ST/SG/AC.10/C.4/2008/14
3 October 2008

**UPDATING OF THE SECOND REVISED EDITION OF THE GLOBALLY HARMONIZED
SYSTEM OF CLASSIFICATION AND LABELLING OF CHEMICALS (GHS)**

Draft amendments to the second revised edition of the GHS

Note by the secretariat¹

“3.8.5.1 Decision logic 3.8.1

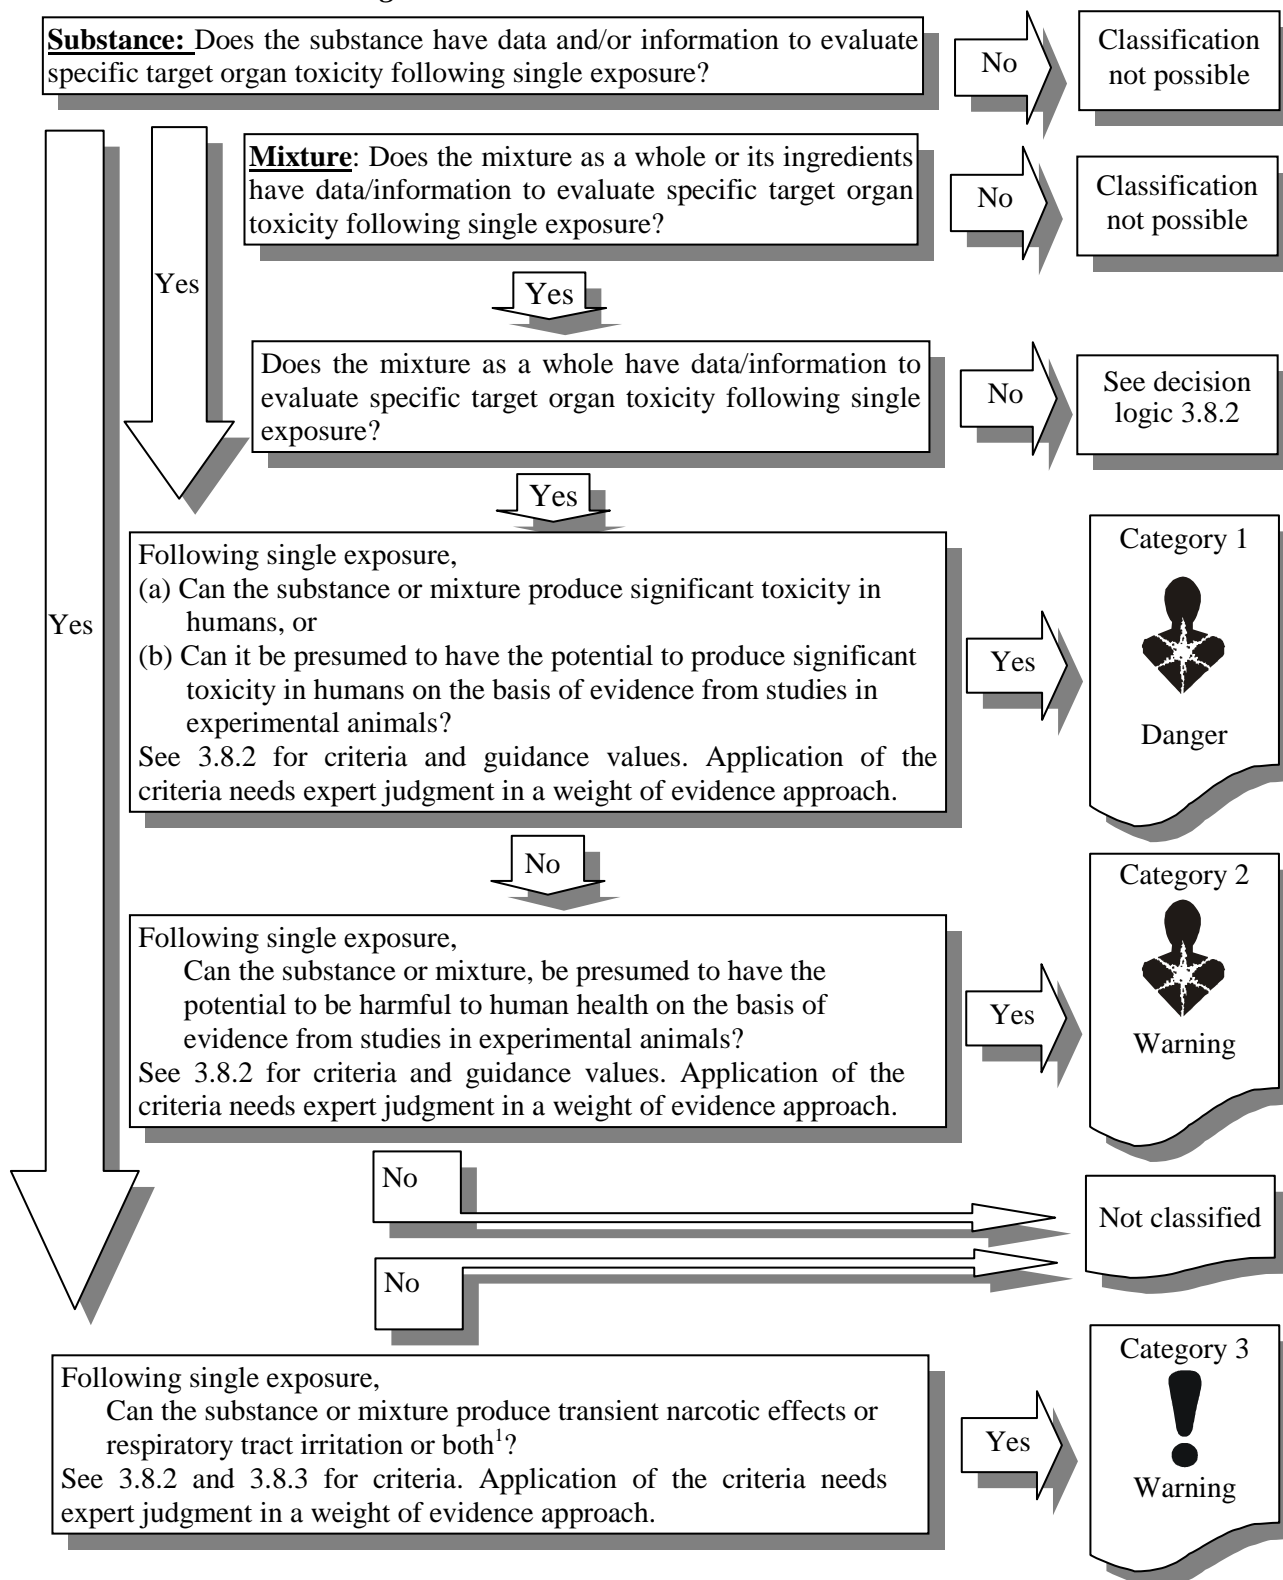
Amend decision logics 3.8.1 and 3.8.2 in chapter 3.8 to read as follows (current introductory paragraph under 3.8.5 remains unchanged):

“Figure 4.1.1: Categories for substances long-term hazardous to the aquatic environment

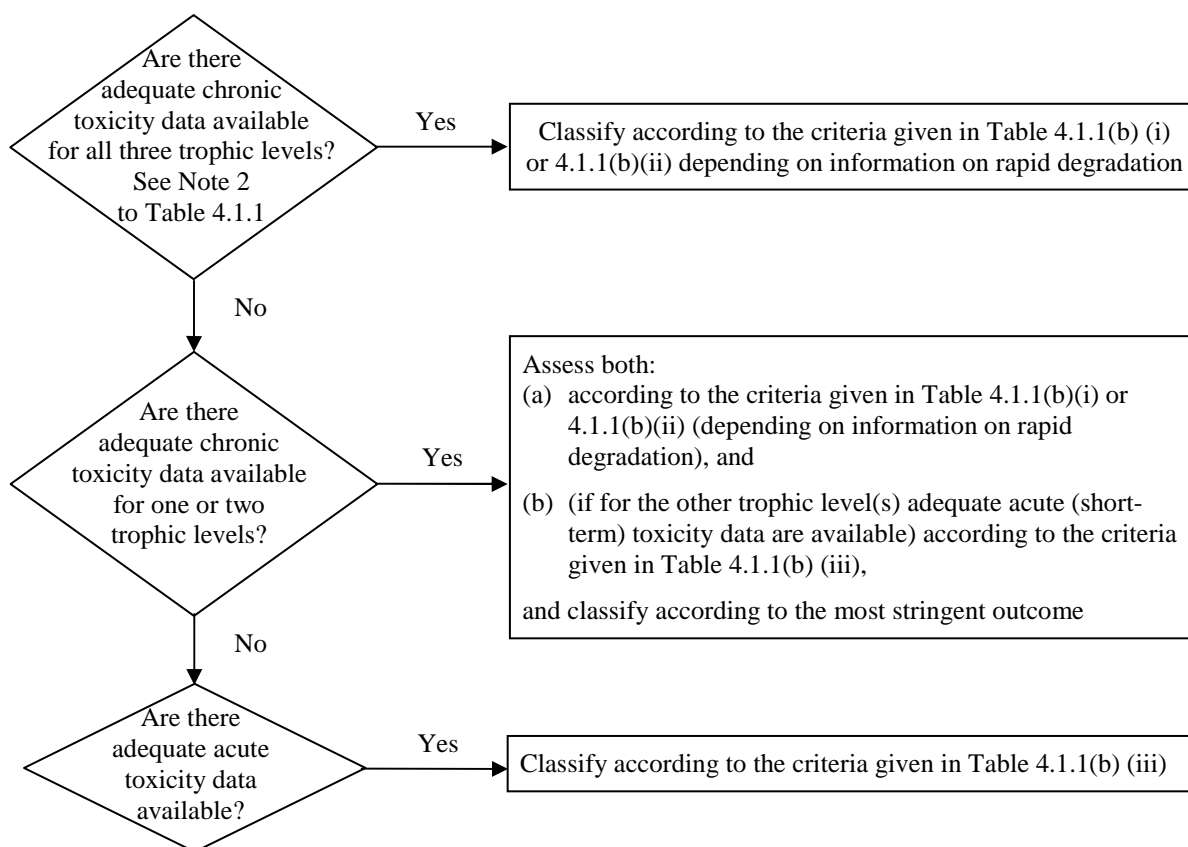
Figure 4.1.1: Insert a new figure 4.1.1 to read as follows:

4.1.5.1.1 Decision logic 4.1.1 for substances and mixtures hazardous to the aquatic environment

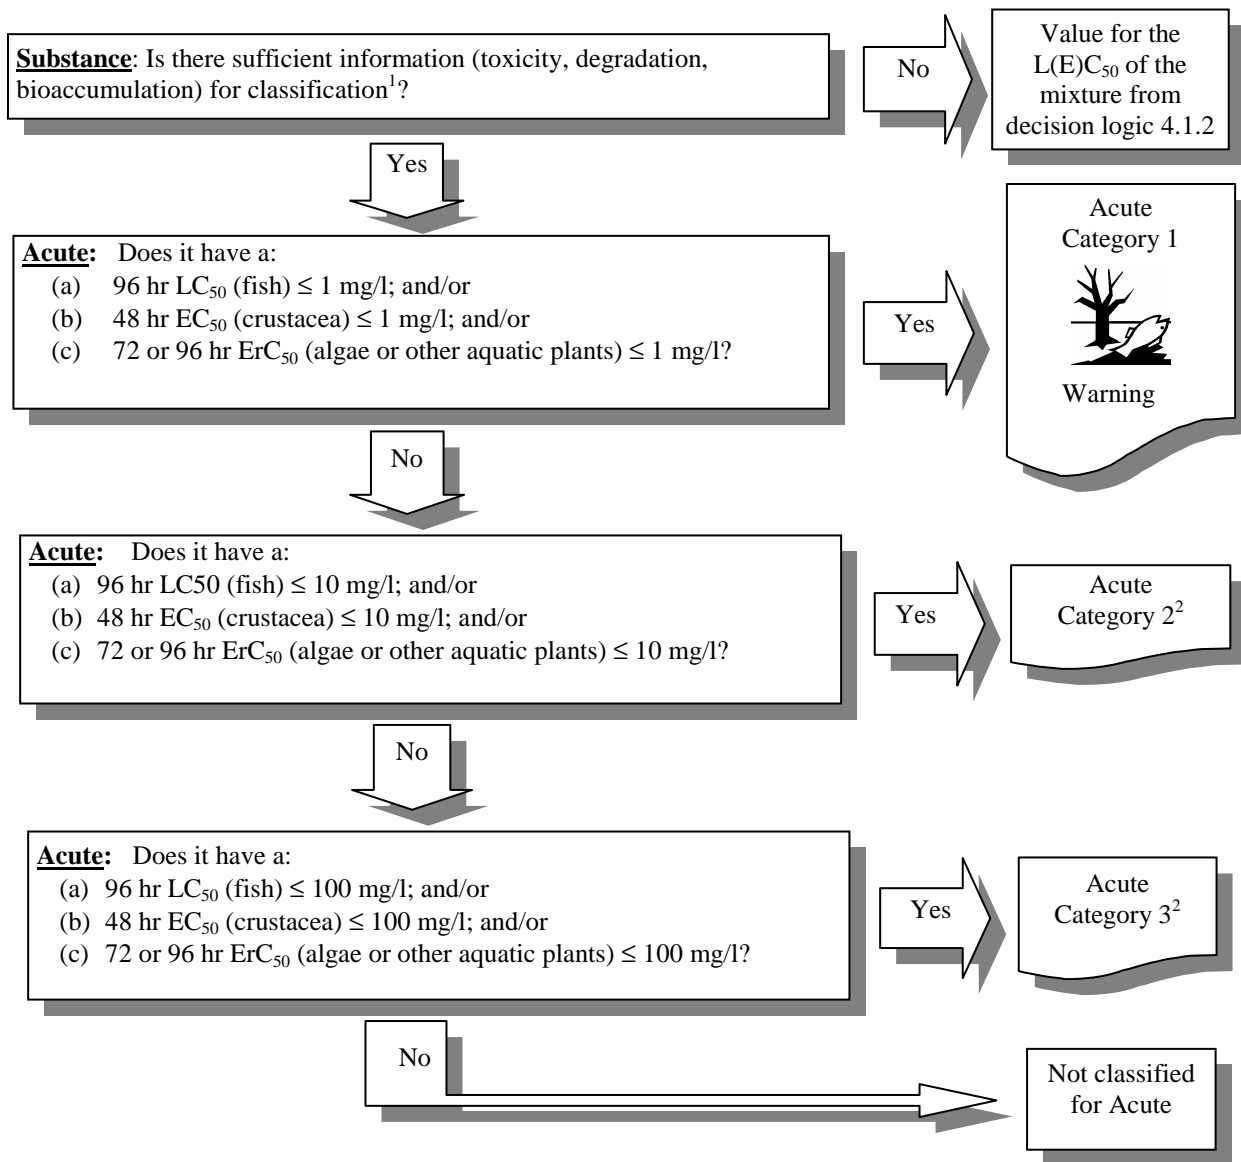
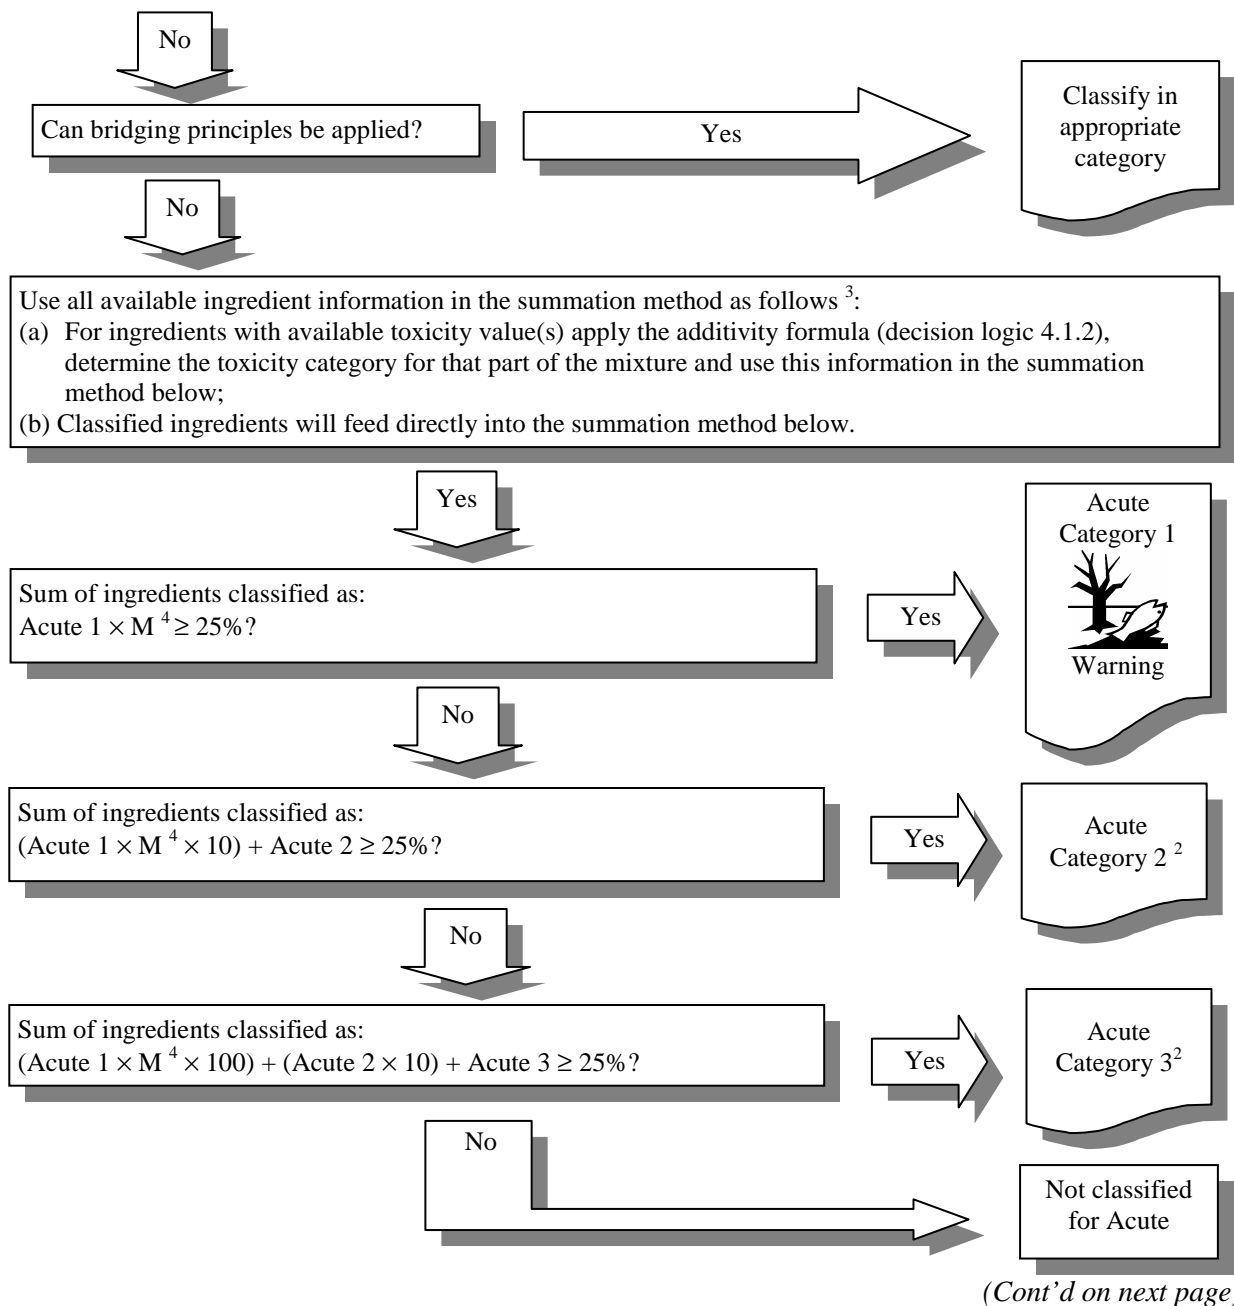
4.1.5.1 Replace current decision logics with the following:
